Non-Conformance Penalties for 2004 and Later Model Year Emission Standards for Heavy-Duty Diesel Engines and Heavy-Duty Diesel Vehicles: Response to Comments

EPA420-R-02-020
August 2002

RESPONSE TO COMMENTS DOCUMENT

Figure 2.3-1

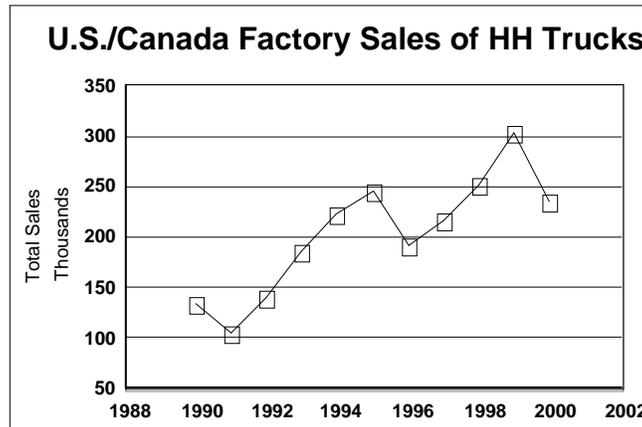
COMMENT: DDC provided detailed recommendations to modify our analysis of fixed costs. They believe that our proposed estimates of fixed costs were amortized over too many engines. First, they stated that manufacturers will attempt to recover the fixed costs associated with the 2004 standards before the new 2007 standards begin to be phased-in. They stated that "it is not correct to assume that the planned EGR system for 2004 will in fact be useable in 2007 and beyond." They argued that manufacturers will take advantage of the averaging provisions for model years 2007-2009 to produce a single technology product rather than produce both very low NOx engines and the 2004-era engines. They suggested that we use a three-year amortization period instead of the proposed five-year period.

DDC also commented that we should base our cost analysis on modeled market volume rather than current sales volumes. They argued that the compliance costs associated with the 2004 standards will affect the market and must be accounted for.

RESPONSE: We continue to believe that a five-year amortization period is appropriate for this analysis. In our recent final rule setting new emission standards for 2007 and later heavy duty diesel engines, we projected that manufacturers would rely on their 2004 technologies to help achieve the more stringent 2007 standards. While it is theoretically possible, as DDC suggested, that a manufacturer could comply on average with the 2007 phase-in requirements using a fully optimized NOx adsorber on an engine without EGR, we do not believe that is likely to be feasible when the standards are fully phased-in. Thus, we fully expect that manufacturers will be using their 2004 technologies in 2010. Given this, we believe that a five-year amortization period is appropriate for this analysis.

With respect to the annual sales volumes, we believe that the 2000 sales volumes represent a good estimate of what sales will be in 2004. There are reasons to believe that sales in 2004 may be higher, but there are also reasons to believe that sales in 2004 may be lower. As shown in figure 2.3-1, since 1990, there has been a long-term trend of increasing annual sales volumes. However, much of this increase was the result of the high economic growth rates observed in the 1990s. At this point, we cannot necessarily project that growth rates between now and 2004 will be that high. Moreover, some manufacturers have expressed concerns that purchaser perceptions may slow sales as the new technology is introduced into the market.
